3. Sterling Airpark Subdivision Scott Addition
KPB File 2025-111
Edge Survey & Design / Scott
Location: Jacobsen Avenue Near Robinson Loop Road
Sterling Area

ITEM #3 - PRELIMINARY PLAT STERLING AIRPARK SUBDIVISION SCOTT ADDITION

KPB File No.	2025-111	
Plat Committee Meeting: August 25, 2025		
Applicant / Owner: Kenneth L. Scott of Sterling, Alaska		
Surveyor:	Jason Young / Edge Survey and Design, LLC	
General Location:	eneral Location: Tail Dragger Circle and Jacobsen Avenue, Sterling

STAFF REPORT

STERLING AIRPARK SUBDIVISION SCOTT ADDITION

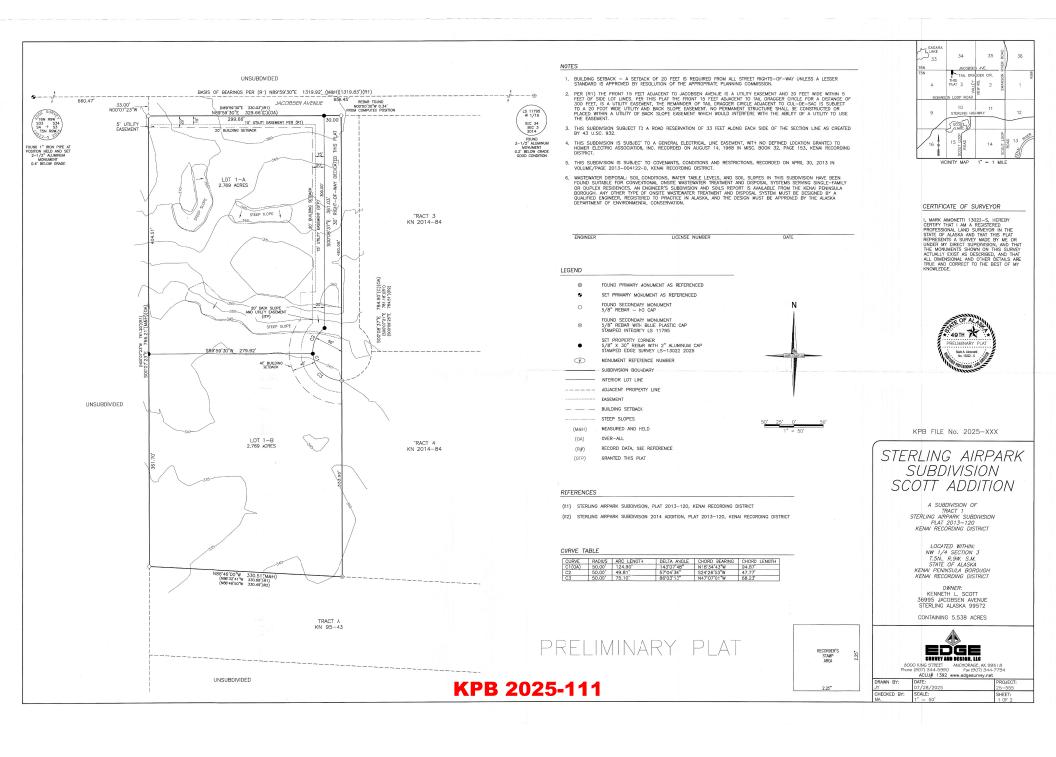
The proposed plat is dedicating 30-feet on the east to the western portion of the existing Tail Dragger Circle right of way and completing the cul-de-sac bulb. A 20-foot back slope easement is also being granted adjacent to the cul-de-sac bulb due to the steep terrain of that area. The KPB Roads Department reviewed the preliminary plat and had no concerns. **Staff recommends** the surveyor provide dimensions of the slope easement and include the easement in the Certificate of Acceptance.

A 30-foot private access easement is located along the western boundary according the easement recorded at document 2013-004121-0 KRD and shown on the parent plat (KN 2013-120). **Staff recommends** this easement be depicted and labeled on the final plat and included on the final certificate to plat.

A 66-foot section line easement exists to the north, 33-feet on either side of the section line. Jacobsen Avenue has been dedicated within the southern half of the section line easement. **Staff recommends** the surveyor depict and label the section line easement on the final plat.

KPB GIS Contours identify steep slopes with grades exceeding 20% on various portions of the plat. 5-foot contours are depicted on the drawing and the steep slopes have been identified with arrows of direction and lines encircling the area. **Staff recommends** the surveyor remove the contours from the final plat, and keep the steep slopes labeled.

Plat note 2 from the parent plat needs to be carried forward and to this plat completely. Dimensioning of the 15' easement should be on the east side of Lot 1-A and in Lot 1-B for clarification.

Plat note 4 needs corrected, as the easement in Bk 32 Pg 153 is defined as being parallel to the north boundary of the lots not to exceed 100'. This easement was shown on the parent plat KN2013-120 as a 100' wide Electric Transmission Line Easement. *Staff recommends* the easement be carried forward from the plat as shown and the plat note be corrected to reference to document details.

HEA has sent a comment concerning the 100' easement and the overhead electric transmission line being the center of the 100' easement and adding a note. HEA comment has also requested a matching 10' utility easement along the east line of Lot 1-B south of Tail Dragger Cir to match to the easement on shown on Lot 4 KN2014-84 to the east

Modify the KPB File Number to 2025-111 on both pages.

- o Total area should include the ROW dedication. Parent Plat states 5.843 acres.
- Modify the Owners address to 37001 Jacobsen Avenue, Sterling, AK 99572

- o Depict section lines and section line easements
- o Add ROW width to label for Jacobsen Circle
- Include a label including width for portion of Tail Dragger Circle to the east dedicated by KN 2014-84
- D. A vicinity map, drawn to scale showing location of proposed subdivision, north arrow if different from plat orientation, township and range, section lines, roads, political boundaries, and prominent natural and manmade features, such as shorelines or streams;

- o Modify Road Name to Scout Lake Loop Road
- F. The location, width and name of existing and platted streets and public ways, railroad rights-of-way, easements, and travel ways existing and proposed, within the subdivision;

- o Add label for Tail Dragger Circle to the ROW being dedicated
- Depict 100' transmission line easement to the north including label referencing plat note of HEA easement
- Depict and label the 30-foot private easement 2013-004121-0 on the west boundary as shown on the parent plat. The final Certificate to Plat should include this easement.
